Technical Service Bulletin

SUBJECT:		No: TSB-20-14-001	
COOLANT LEAKAGE FROM RADIATOR		DATE: May 2020	
		MODEL: 2014-20 Outlander	
CIRCULATE TO:	<input type="checkbox"/> GENERAL MANAGER	<input checked="" type="checkbox"/> PARTS MANAGER	<input checked="" type="checkbox"/> TECHNICIAN
<input checked="" type="checkbox"/> SERVICE ADVISOR	<input checked="" type="checkbox"/> SERVICE MANAGER	<input checked="" type="checkbox"/> WARRANTY PROCESSOR	<input type="checkbox"/> SALES MANAGER

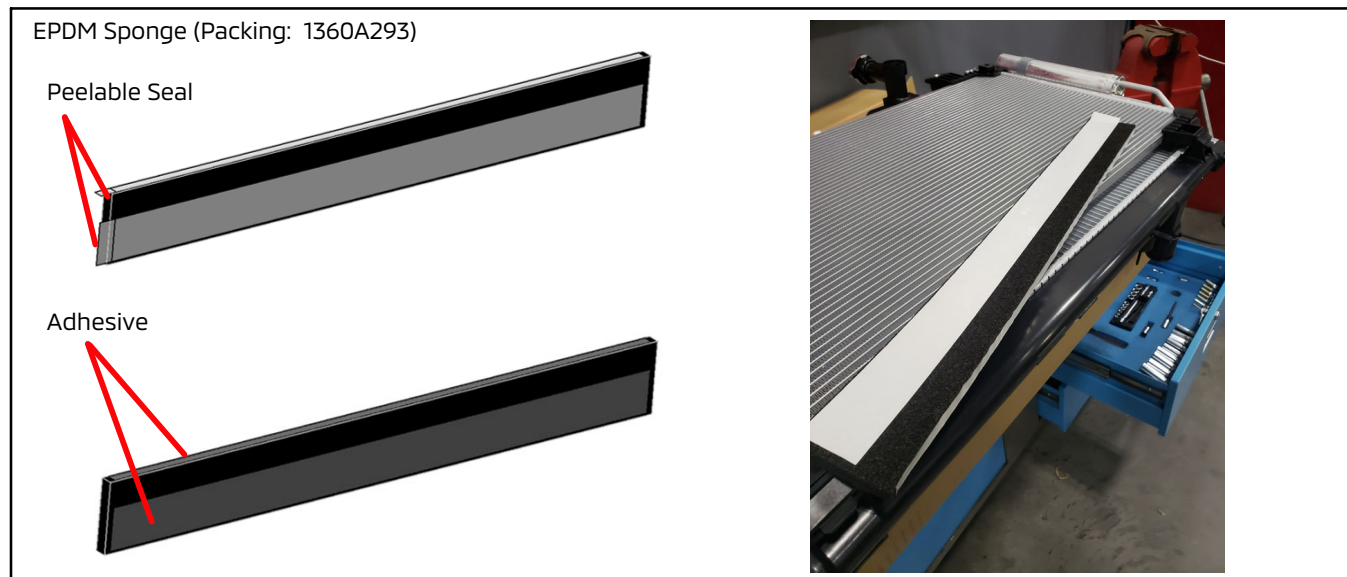
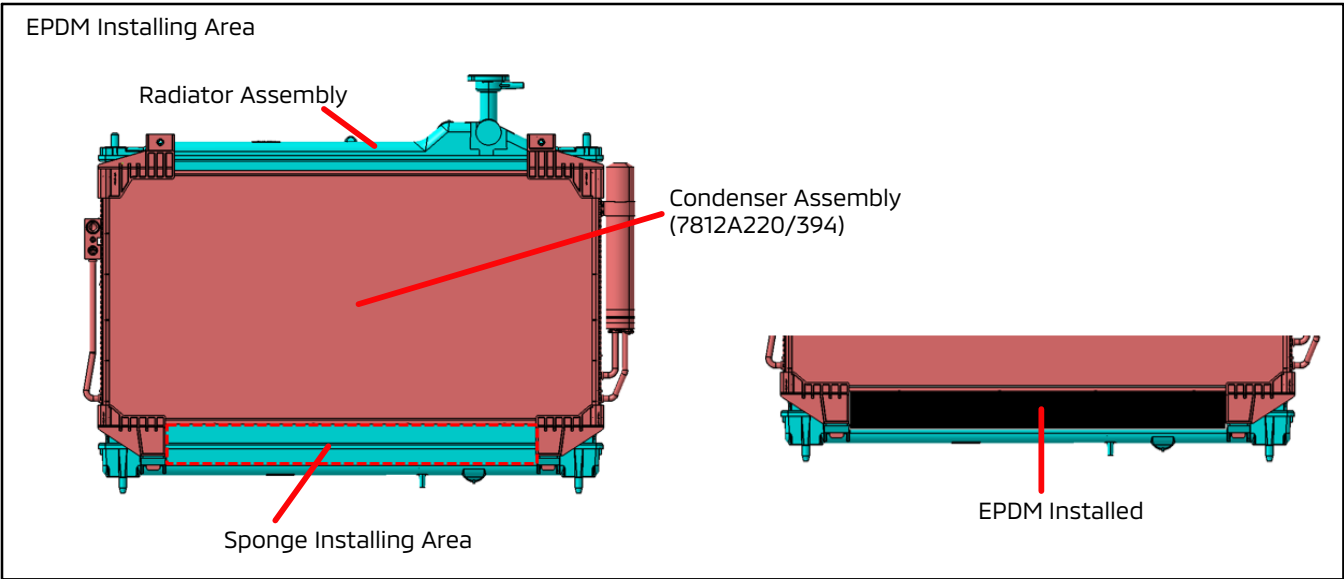
A customer may report a water temperature warning light after coolant leakage occurs. This may happen when stones from the road enter through the bumper opening and damage the radiator core tube.

This TSB instructs dealers how to install a new radiator and add an EPDM sponge which covers the exposed radiator core.

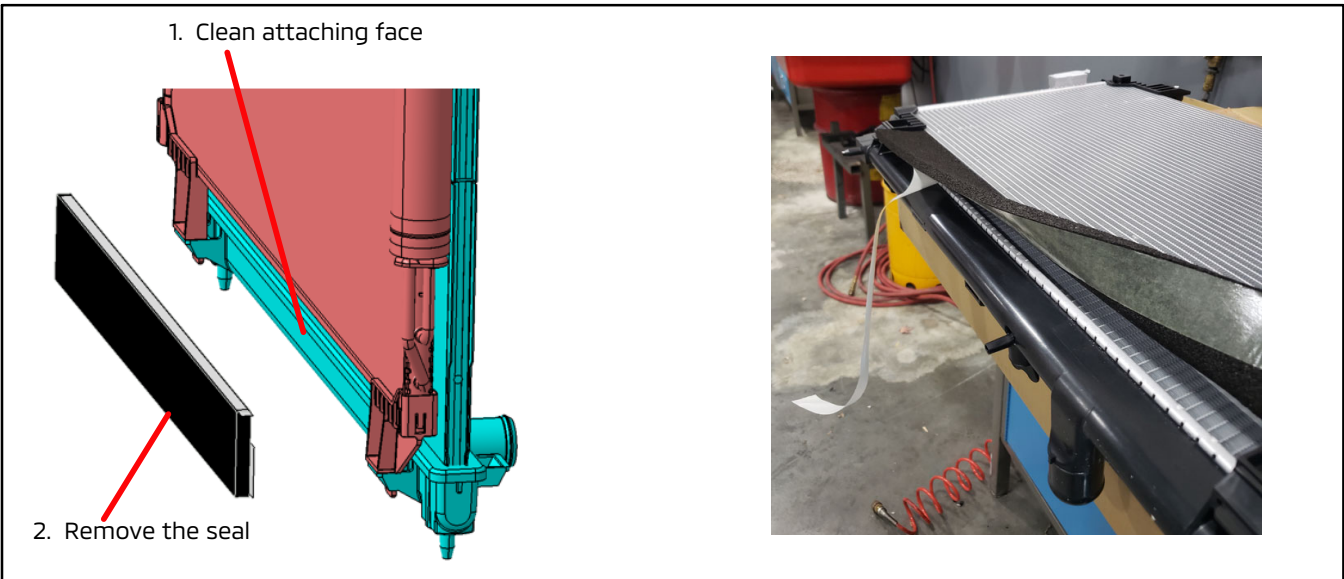
Replace the radiator with a new one and install the EPDM sponge (packing) covering the exposed radiator core referring to the steps below.

1. Clean the attaching face of the radiator.
2. Remove the peeling seal.

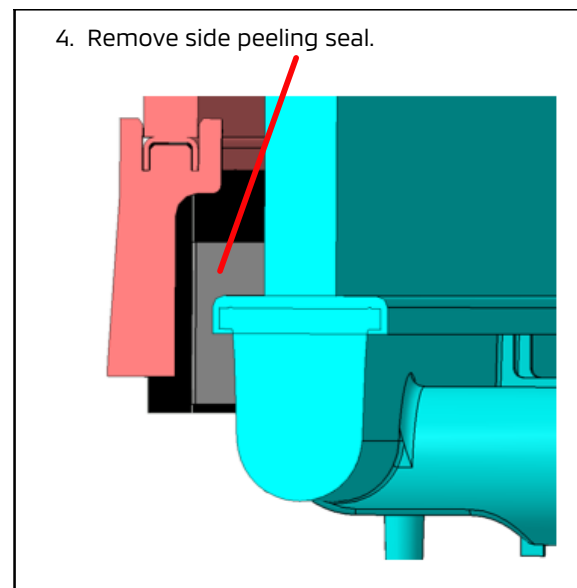
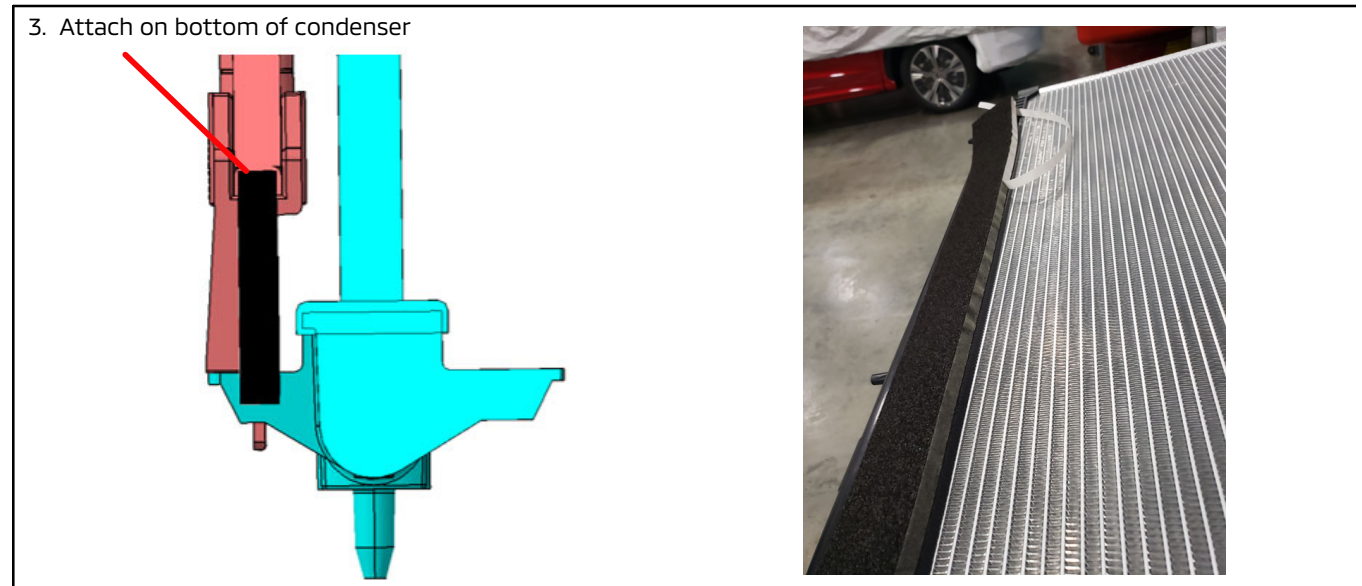
3. Attach on the bottom of condenser (bottom of concave).

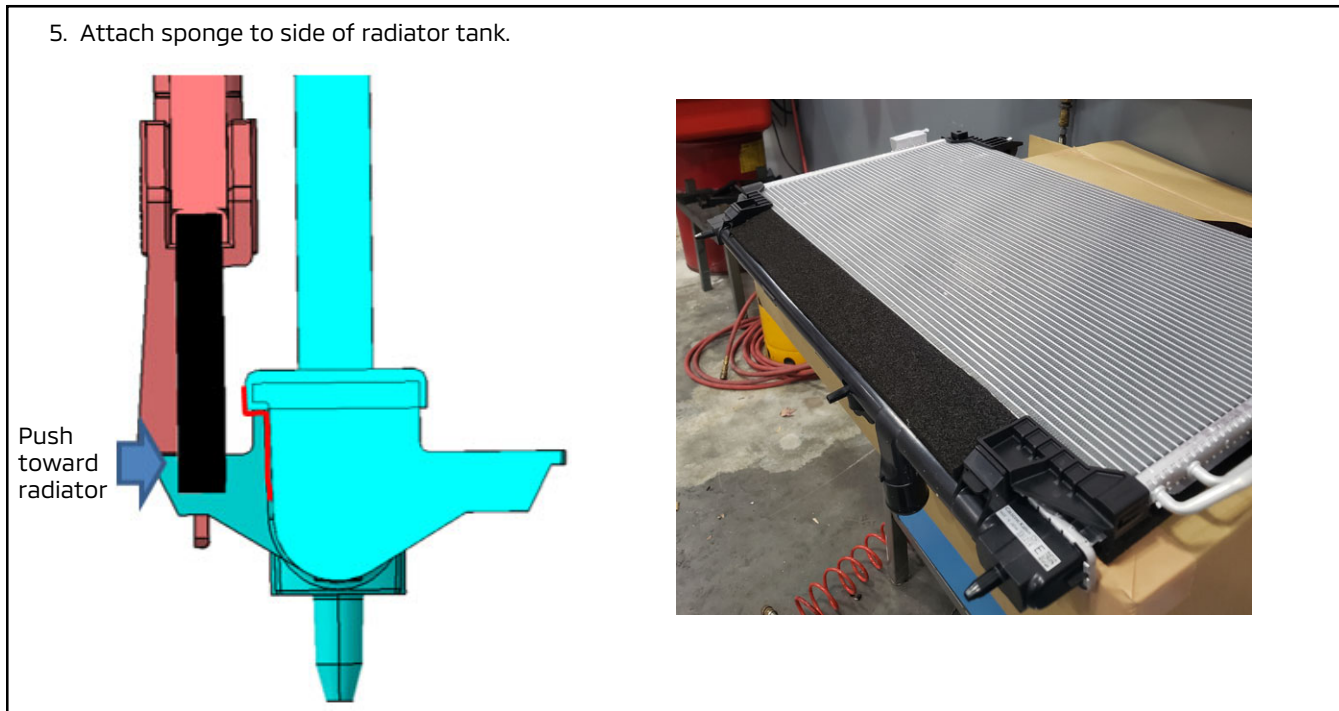
4. Remove the side peeling seal.

- Adhere/push the sponge toward the red line in the diagram so that it is attached on the side of the radiator tank.

Confirm the sponge is firmly attached and does not come off.
